**ADDENDUM # 1 TO BID INVITATION # 135-16**

FOR: STAINLESS STEEL SLIDE GATE

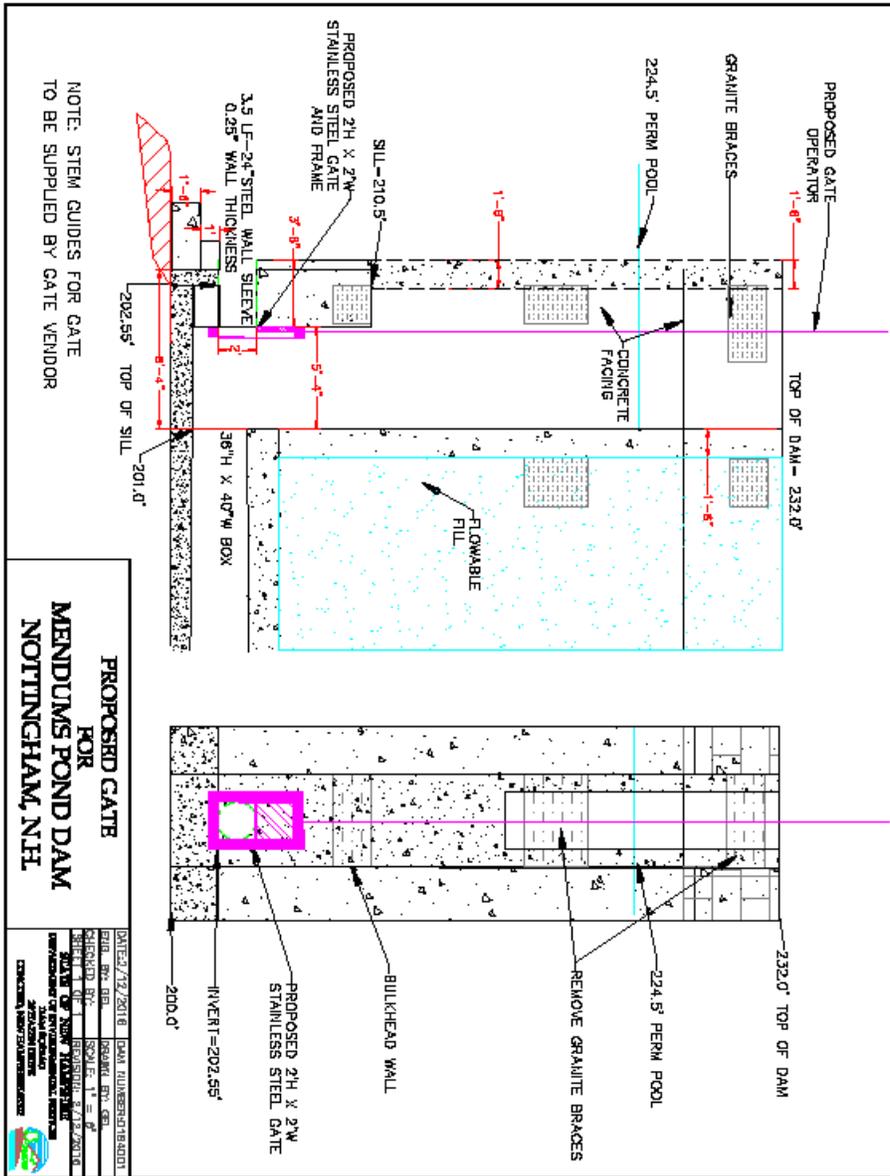
**ADD:**

Please see the diagram below:
